# THE HILLS AT LORSON RANCH COLLECTOR STREETS STREET, STORM SEWER, WATERMAIN, SANITARY SEWER CONSTRUCTION PLANS

THE HILLS AT LORSON RANCH  
COLLECTOR STREET  
CONSTRUCTION PLANS

PROJECT NO.  
100.061  
SHEET NUMBER  
C0.1  
TOTAL SHEETS: 58

STREET & STORM SEWER PLAN/PROFILE  
 FONTAINE BOULEVARD  
 STA 189+16 TO STA 196+00

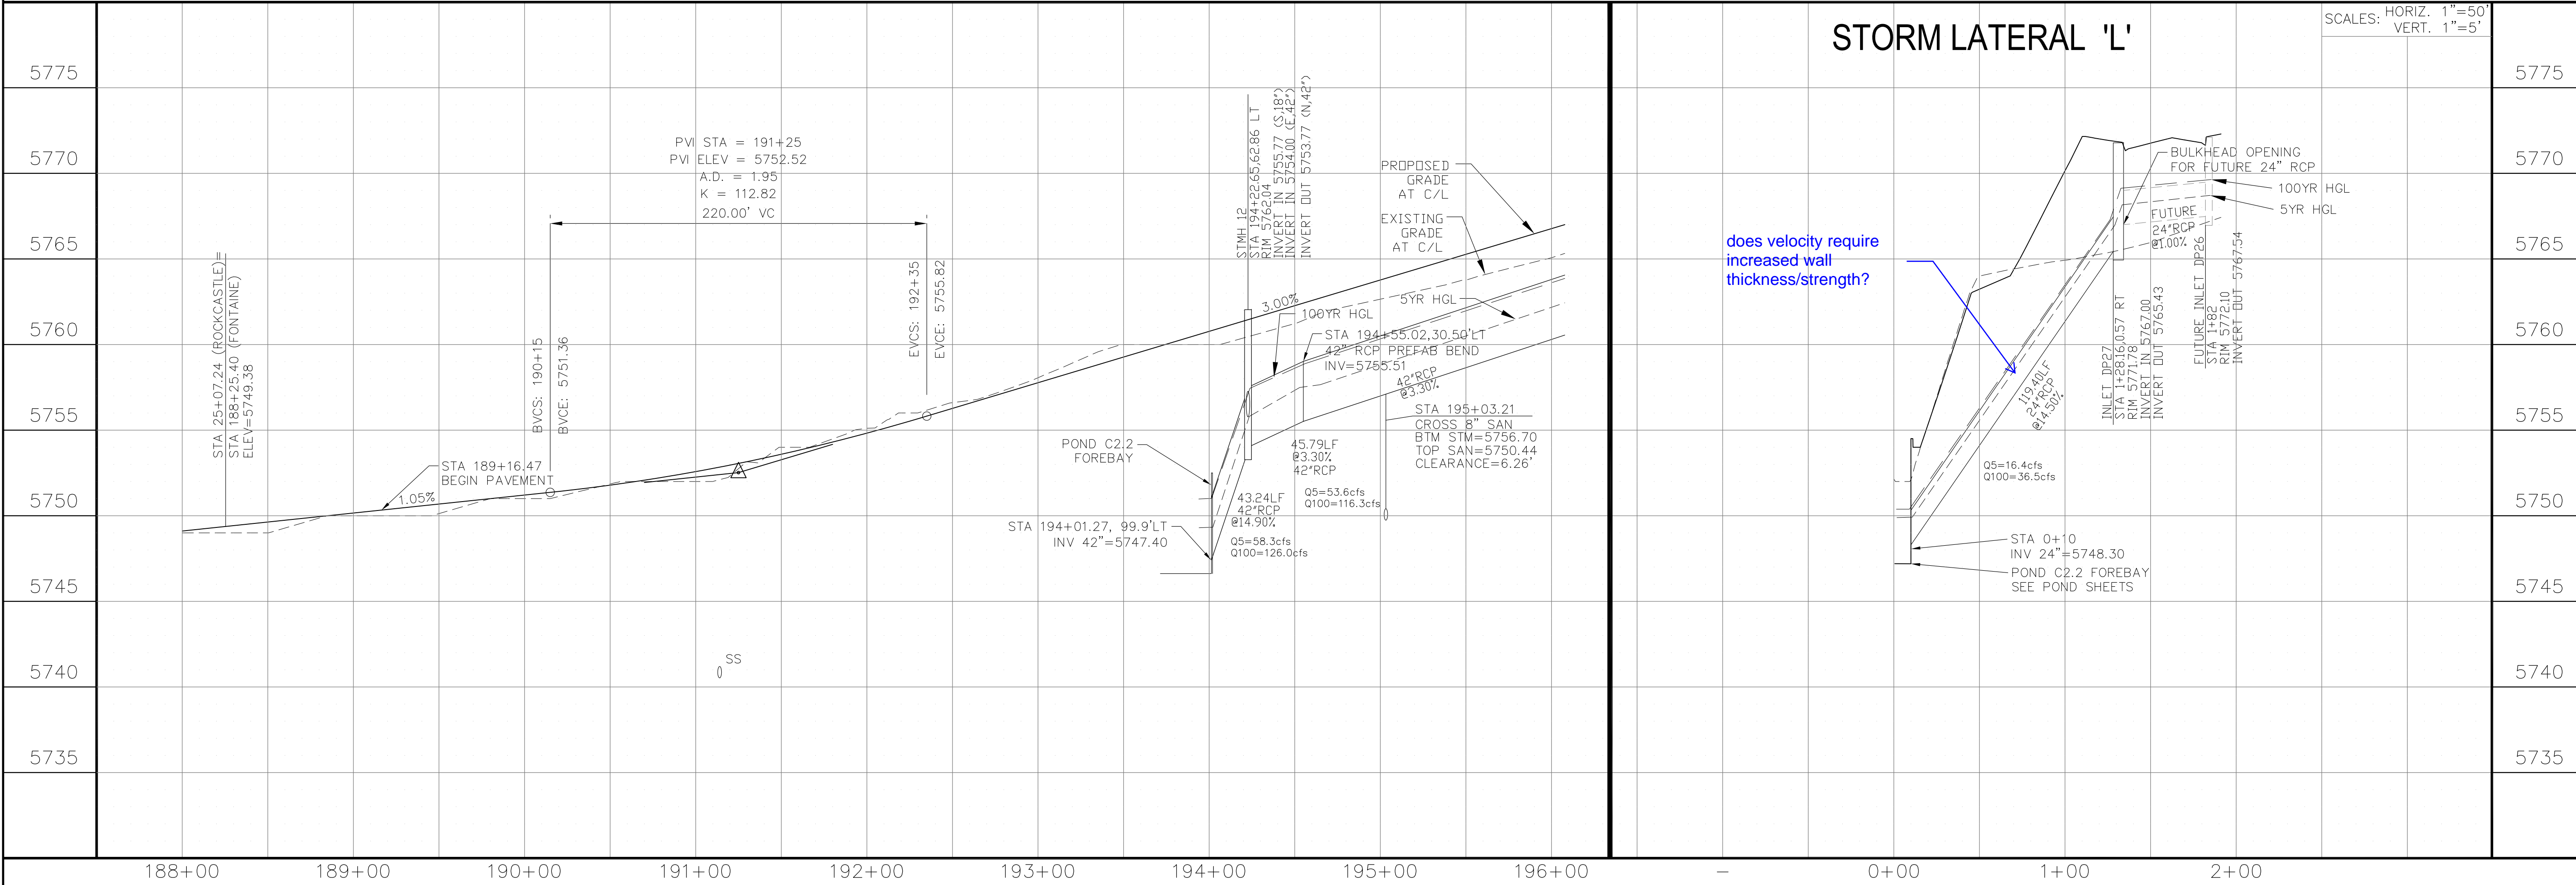
does velocity require increased wall thickness/strength?

**STREET & STORM SEWER PLAN/PROFILE**  
**FONTAINE BOULEVARD**  
**STA 196+00 TO STA 203+25**

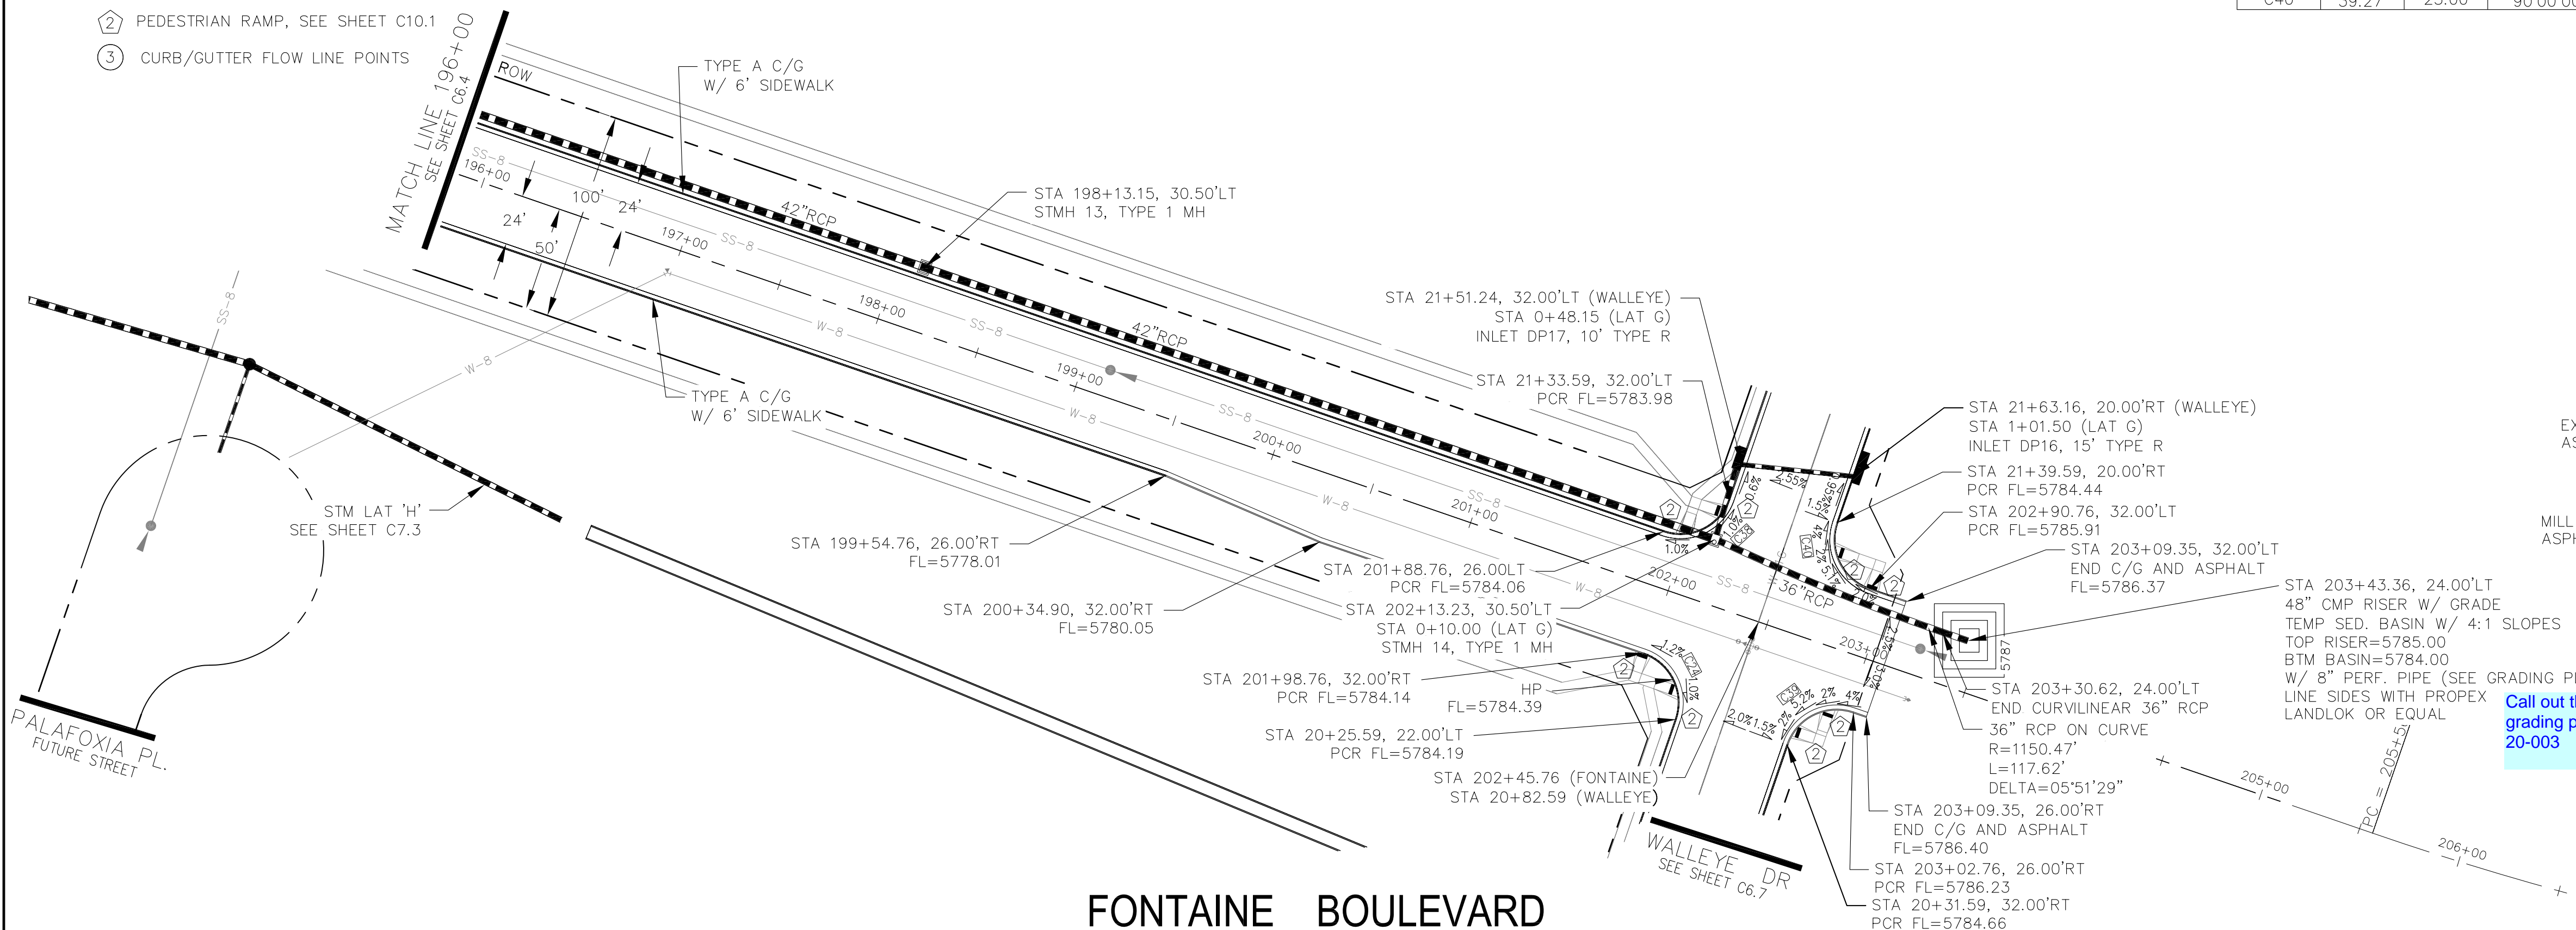
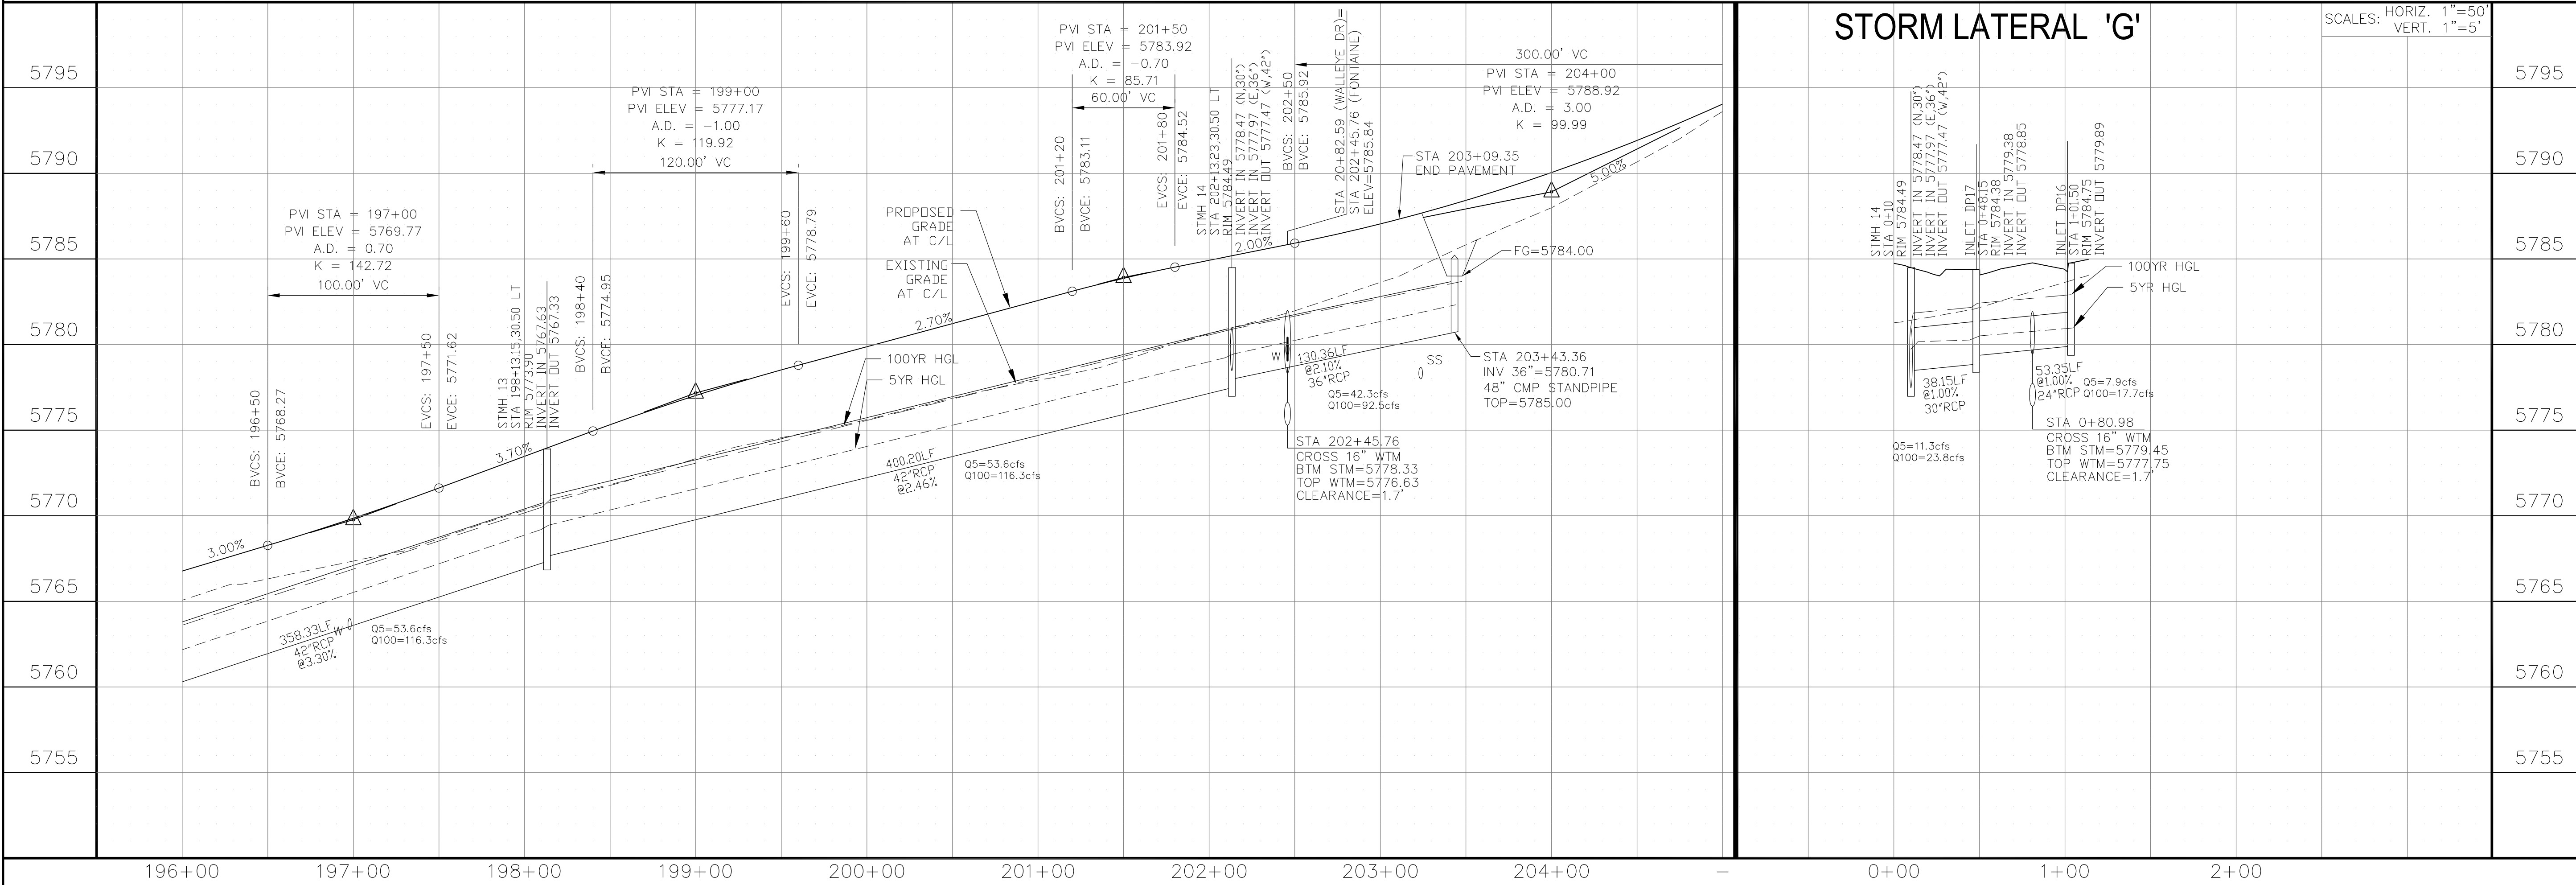
Call out the project for the grading plans PUDSP 20-003

**WTM AND SANITARY PLAN/PROFILE**  
**LORSON BOULEVARD**  
**STA 103+00 TO STA 111+20**

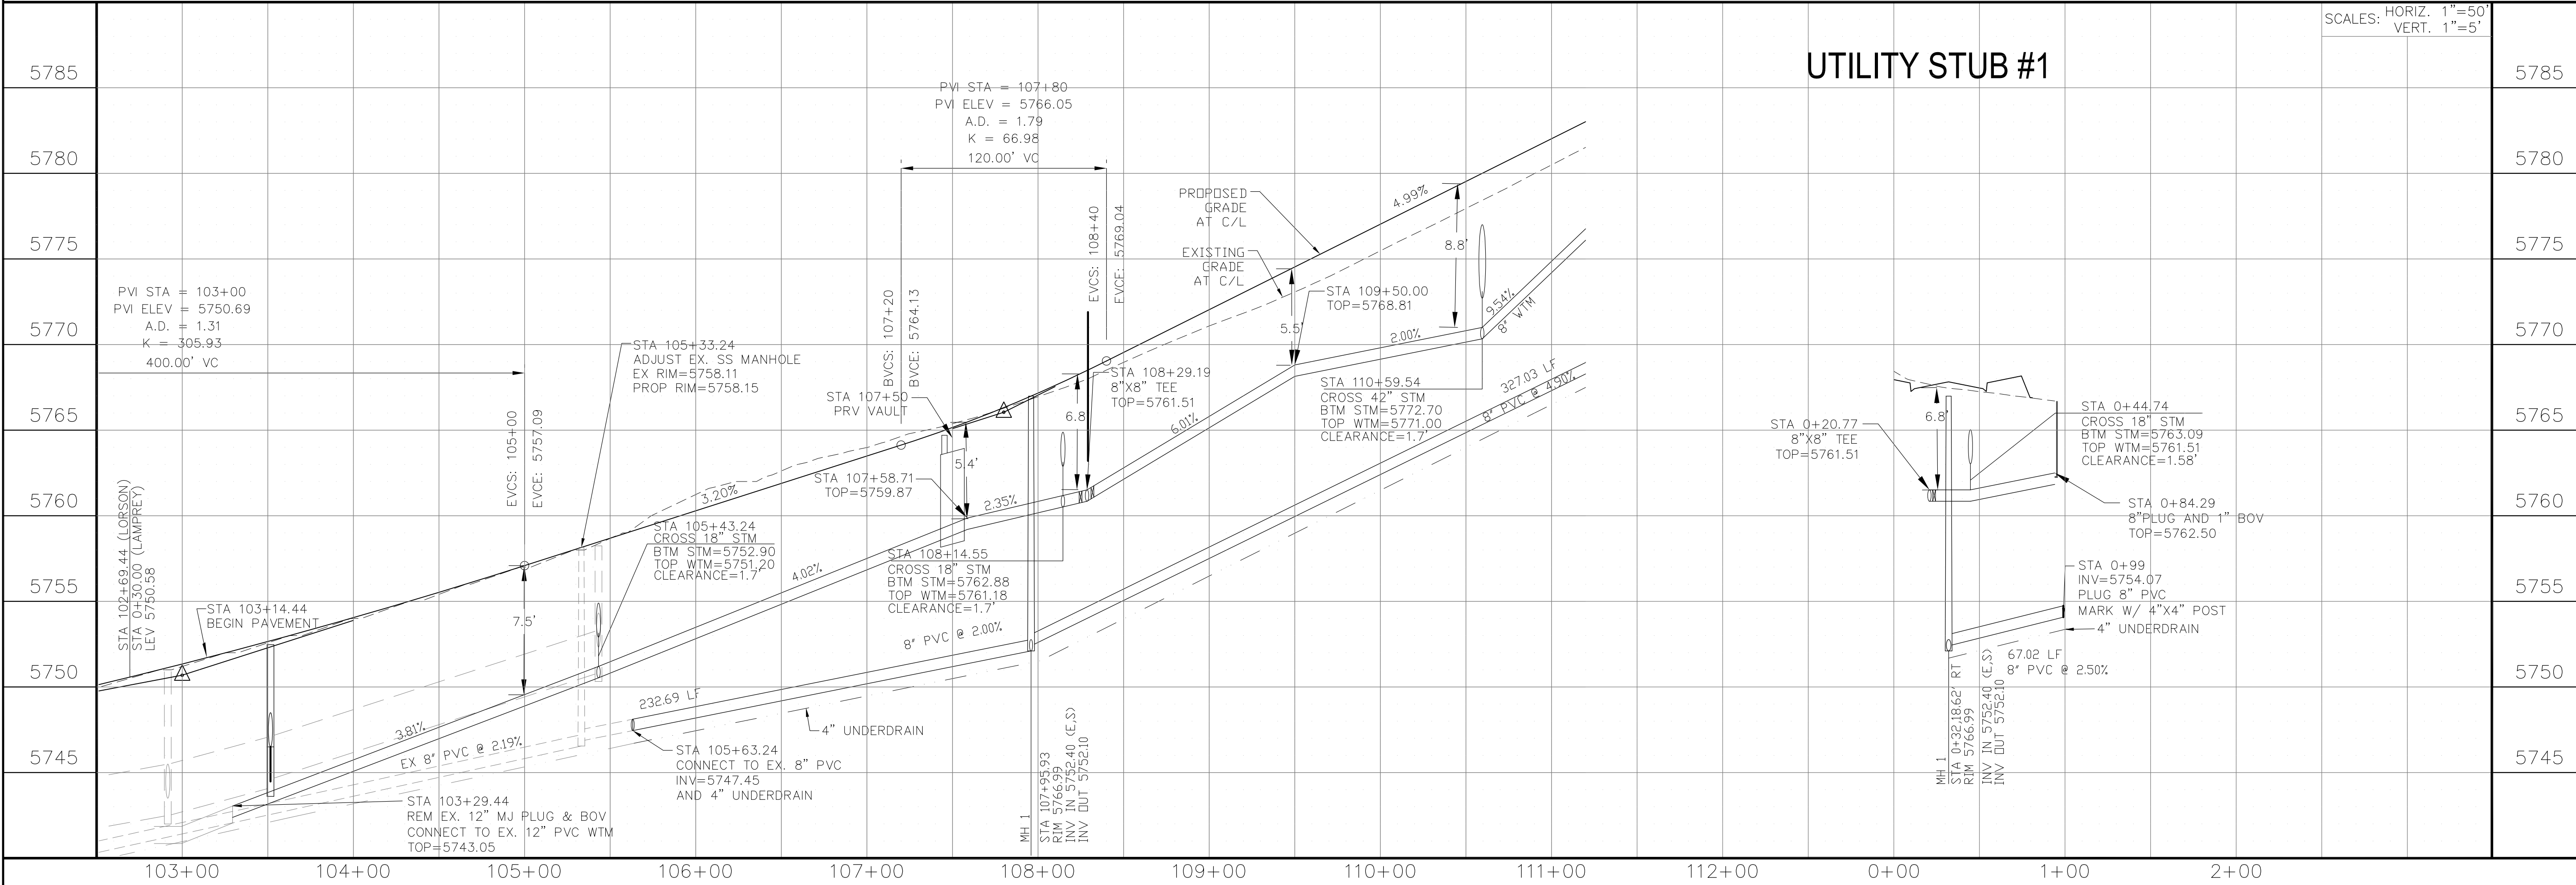
Indicate under drain outfall. (underdrain continues down Lorson and outfalls into JCC?)
